## DEVELOPMENT HEARING OFFICER

### Planning - Case Comments

**Project Number:** PR-2024-010039

**Project Name:** 1924 Leon Ct NW

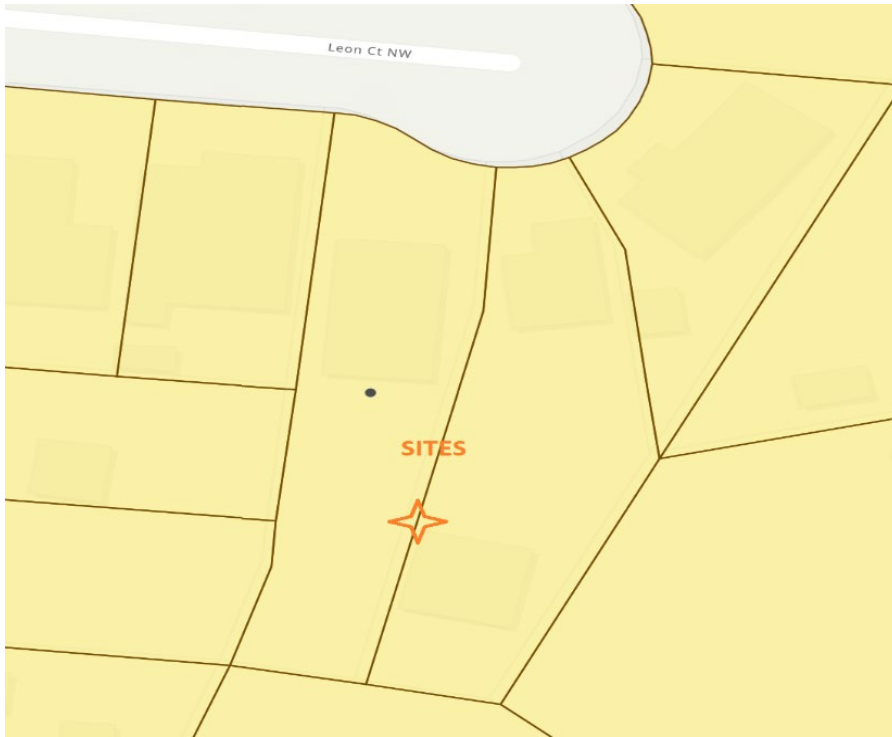
- This is a request for a replat to adjust the property line between two lots to create two new lots in the Luke Subdivision (Lot 6-A-1, Block C at 0.2545-acres in size, and Lot 6-B-1, Block C at 0.1435-acres in size). The lot line adjustment would include the garage in the SE portion of the property in order to drive vehicles more easily to the backyard. This site is zoned R-A (Residential- Rural & Agricultural)
- The subject property is NOT located within any type of Center or Corridor. It is Area of Consistency and not within any Character Protection Overlay (CPO).
- The subject property is located within the boundaries of Rio Grande Boulevard Neighborhood Association.
